From: Kelli Graff <kelli.graff@whiting.com>
Sent: Wednesday, January 06, 2016 11:01 AM
To: Cardwell, Sara J.
Cc: Rich Brierley; Cory Tuhy; Kevin Archer; Randy Heitz
Subject: Fwd: Cases No. PU-08-843, PU-08-844 and PU-11-102
Attachments: image003.jpg

From: Cardwell, Sara J. [<mailto:scardwell@nd.gov>]
Sent: Tuesday, November 03, 2015 3:26 PM
To: Kelli Graff
Subject: Cases No. PU-08-843, PU-08-844 and PU-11-102

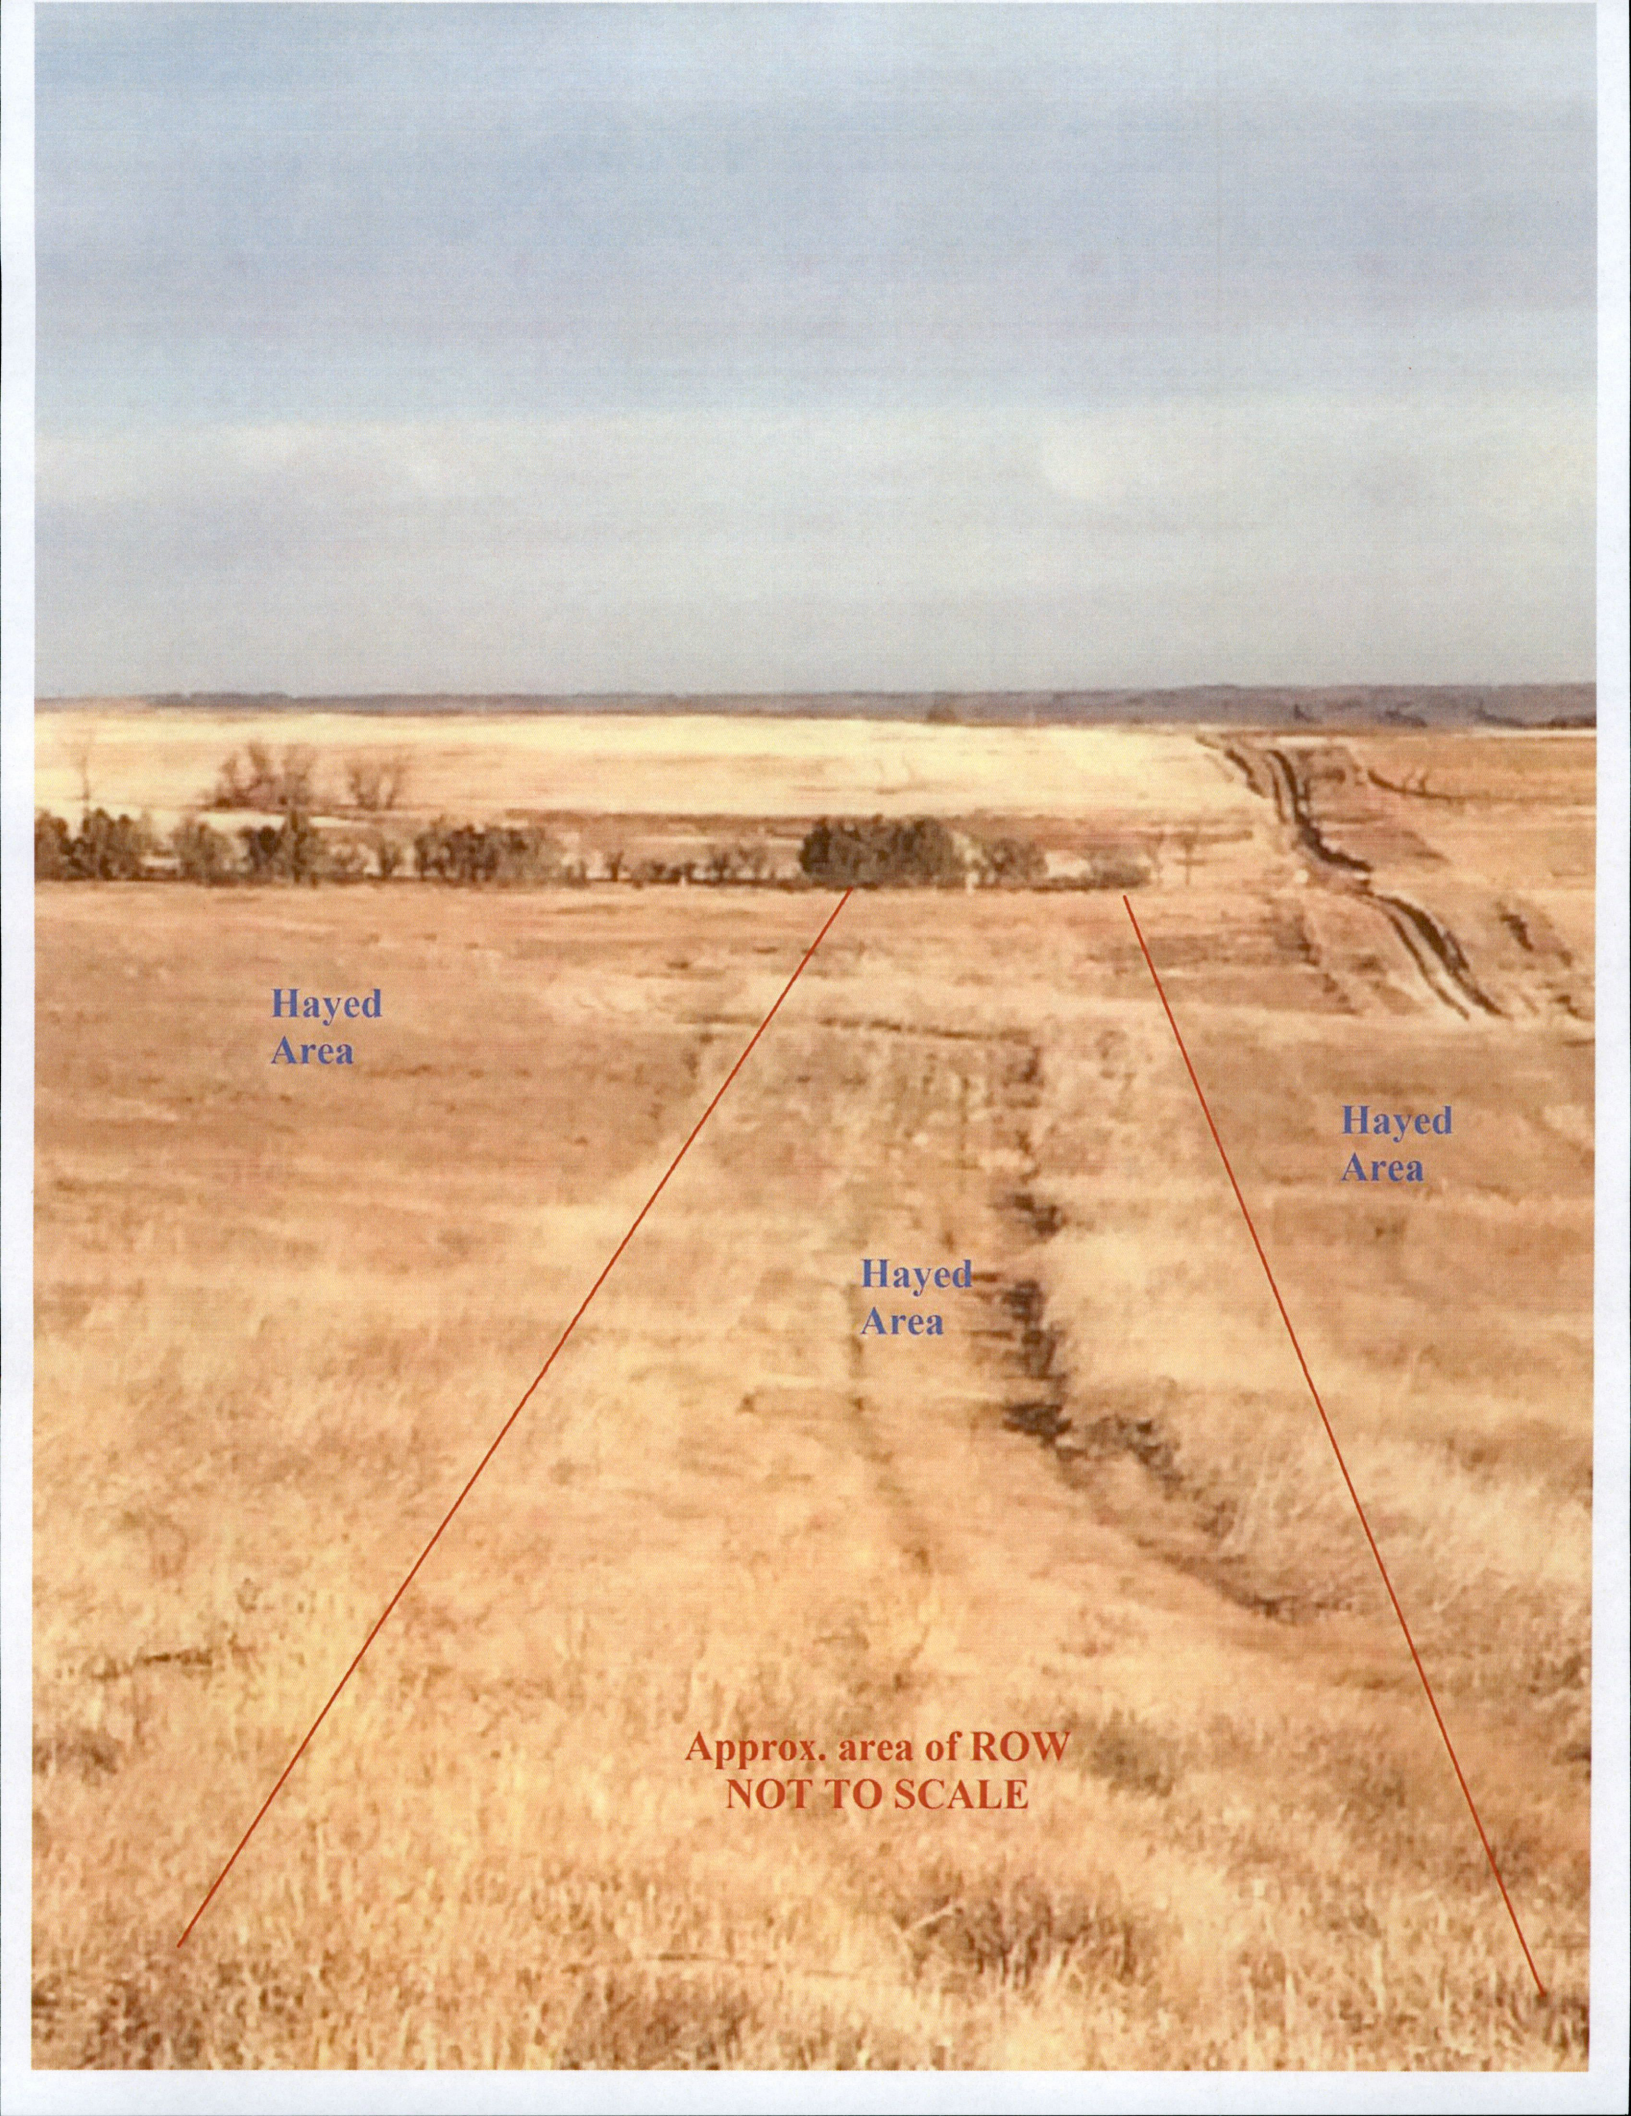
In looking at the following pictures: 5847, 5839 and 5837, I'm wondering who is responsible for the road – is that a property owner or Whiting's responsibility?

...the area in the center of 5847 or behind the trees in 5837 and 5839. Is this the path of the pipelines? If so, it appears that the land at a minimum needs further revegetation if not additional leveling so it matches up with the other land around it & doesn't look scarred.

Good talking to you Kelli & I understand it may take you a while to get back to me with snow on the ground. In looking at the following pictures: 5847, 5839 and 5837, I'm wondering who is responsible for the road – is that a property owner or Whiting's responsibility. As if it is Whiting's responsibility, there is some work that needs to be done to control erosion. The second issue is the area in the center of 5847 or behind the trees in 5837 and 5839. Is this the path of the pipelines? If so, it appears that the land at a minimum needs further revegetation if not additional leveling so it matches up with the other land around it & doesn't look scarred.

This is a section line or often times referred to as a prairie trail. They are public access and not actively maintained by the county or township jurisdiction that owns them for right of way. This is not a Whiting responsibility.

The 5843 and 5847 pictures show evidence of haying. The short stands of grass are where the cutting and baling of hay occurred. The growth on the pipeline ROW was better than some of the native grass and had been swathed over for hay. There is a regrowth of alfalfa standing that grows faster than the grasses and may create a visual of uneven terrain. Alfalfa is valued as a hay crop and turns brown after frost when the photo was taken. Regrowth will occur in the spring.

**Hayed
Area**

**Approx. area of ROW
NOT TO SCALE**
